Re: NM Sol/ Phase 1 Tenant Addition
7402 Los Volcanes Rd. NW
Traffic Circulation Layout
Architect's Stamp 03-28-23 (J10-D027)

Based upon the information provided in your submittal received 04-11-23, the above referenced plan cannot be approved for Building Permit until the following comments are addressed:

ARCHITECTURAL SITE PLAN
TRAFFIC CONTROL LAYOUT

AS102 TCL

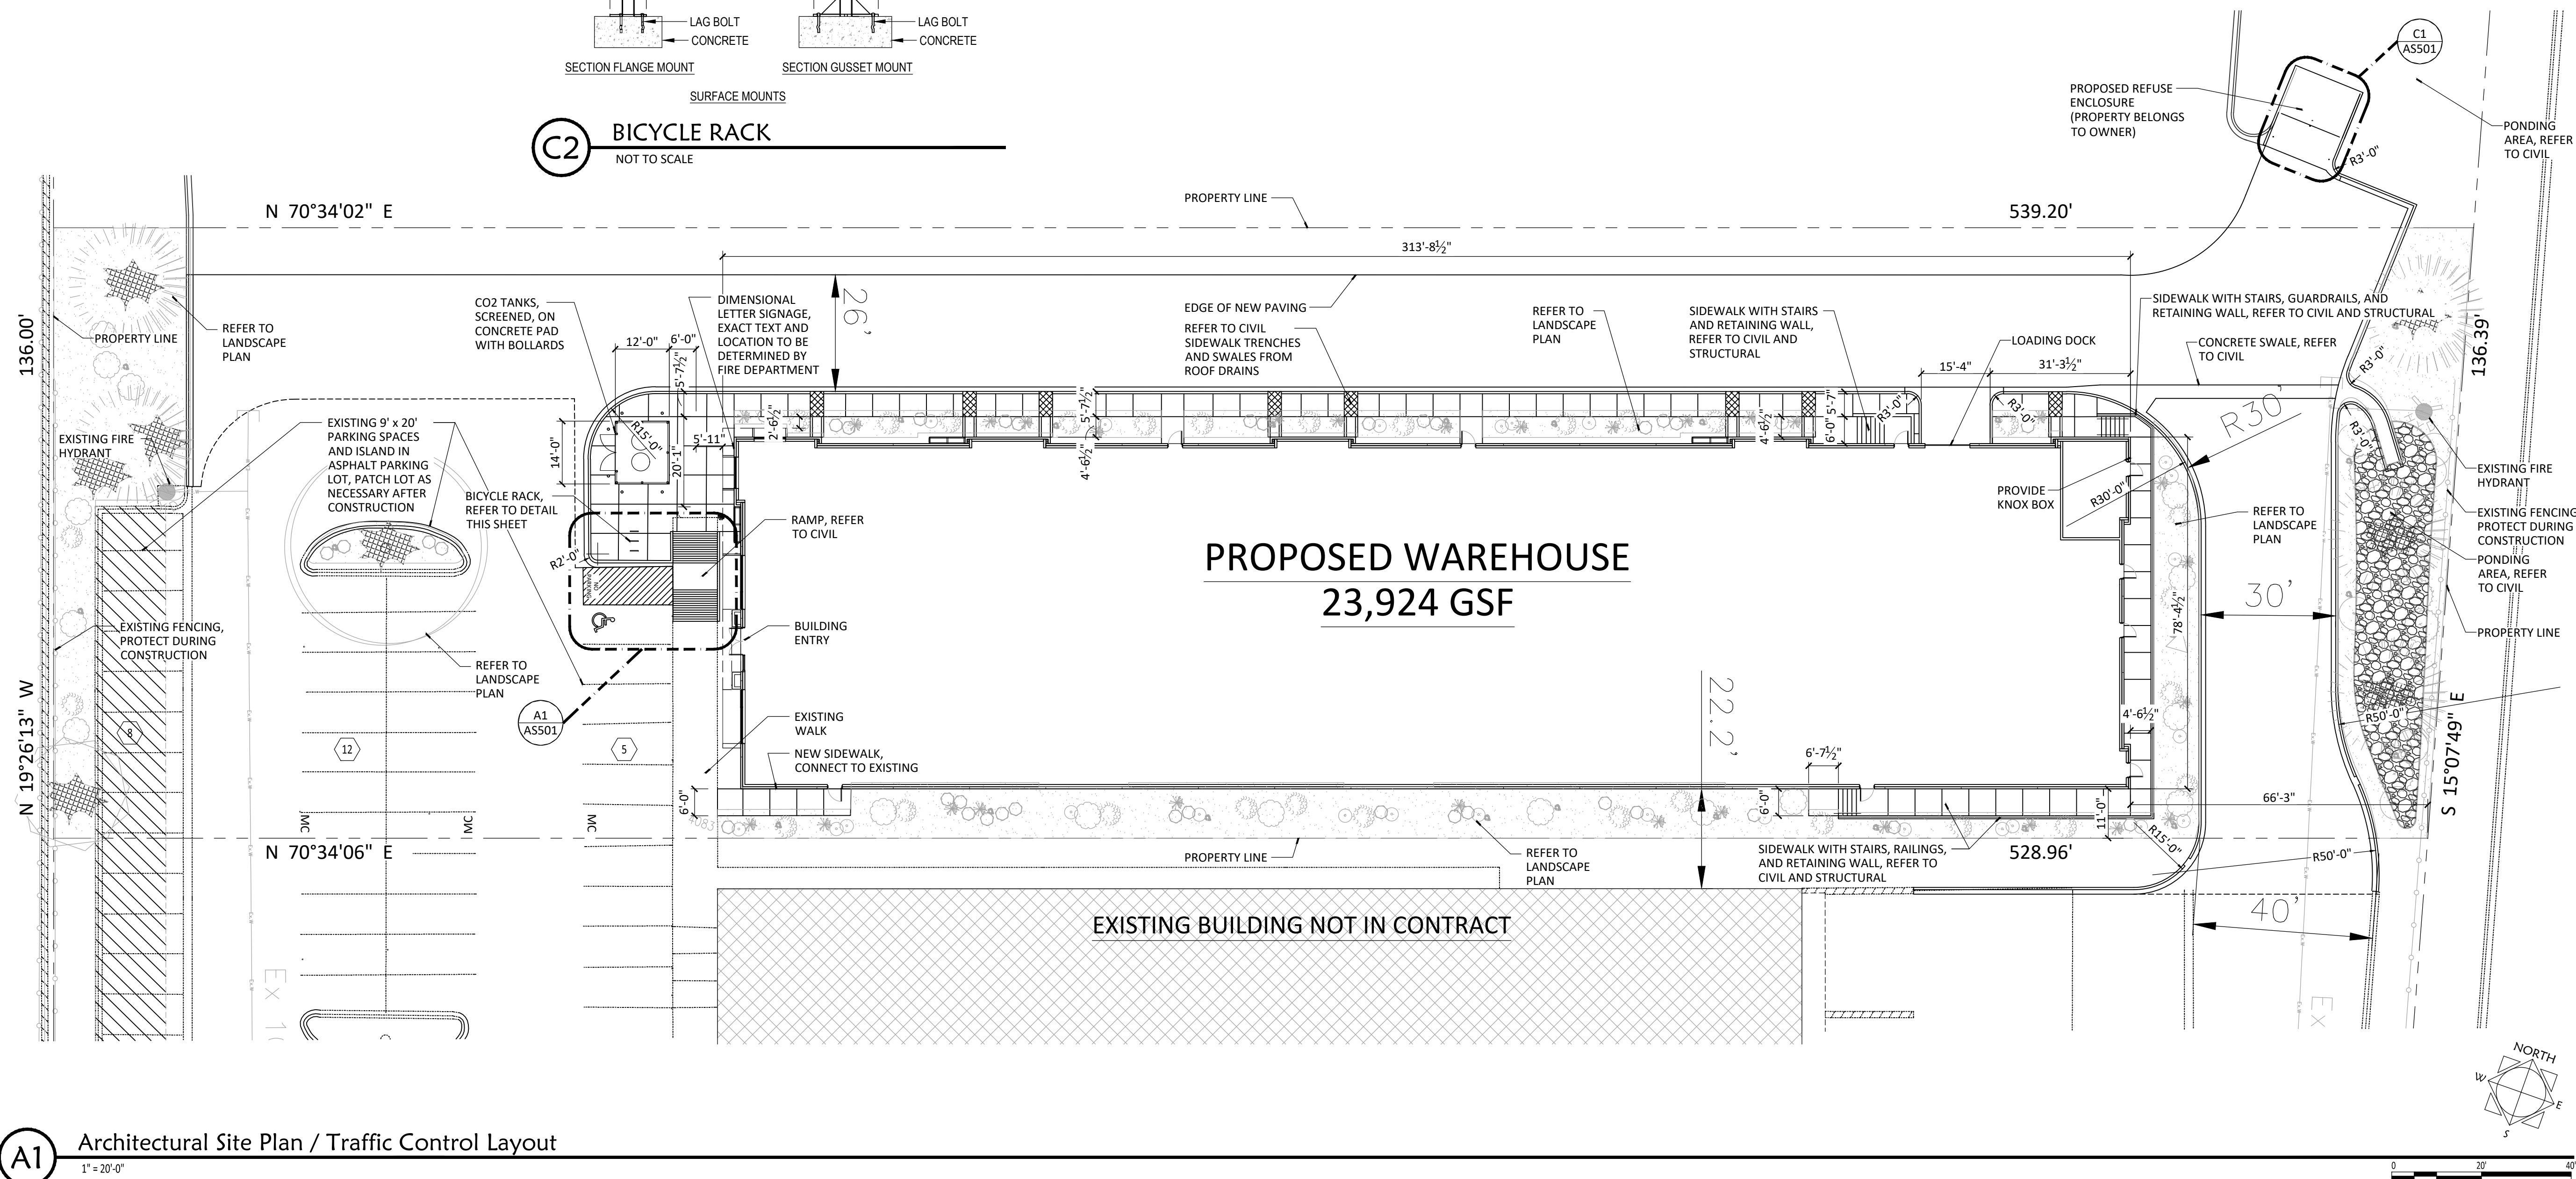
1. Identify all existing access easements and rights of way width dimensions.
2. Is the proposed Warehouse behind or in front of the existing building? Please clarify.
3. Please show the site accesses on the site plan, and site accesses must be updated to the current ADA standard.
4. Please show the dimensions for all the proposed parking spaces.
5. Show all drive aisle widths and radii. Some dimensions are not shown.

Minimum Drive Aisle Width
Two Way Traffic	22'
Main Circulation Road	24'
Fire Lane	20'

6. Per the IDO, a 6 ft. wide ADA accessible pedestrian pathway is required from the public sidewalk to the building entrances. Please clearly show this pathway and provide details.
7. Per DPM, a 6 ft. wide ADA accessible pedestrian pathway is required from the ADA parking stall access aisles to the building entrances. Please clearly show this pathway and provide details.
8. ADA accessible pedestrian pathway should not be placed behind parking space or adjacent to a vehicular way. Vehicle and pedestrian/wheel chair conflicts should be avoided as much as possible.
9. Curbing should be installed to delineate landscape, parking, and pedestrian ways and identify points of access. Please call out detail and location of barrier curb.
10. Refuse vehicle maneuvering shall be contained on-site. The refuse vehicle shall not back into the public right of way.; provide a copy of refuse approval.

11. Please provide a copy of Fire Marshal approval.
12. It is not apparent what type of pavement surface is being proposed. A hard driving surface will be required as part of this proposed project for parking area and drive aisles.

13. Show the clear sight triangle and add the following note to the plan: "Landscaping and signage will not interfere with clear sight requirements. Therefore, signs, walls, trees, and shrubbery between 3 and 8 feet tall (as measured from the gutter pan) will not be acceptable in the clear sight triangle.

14. Please specify the City Standard Drawing Number when applicable.
15. Add a note stating "All broken or cracked sidewalk must be replaced with sidewalk and curb & gutter." A build note must be provided referring to the appropriate City Standard drawing.
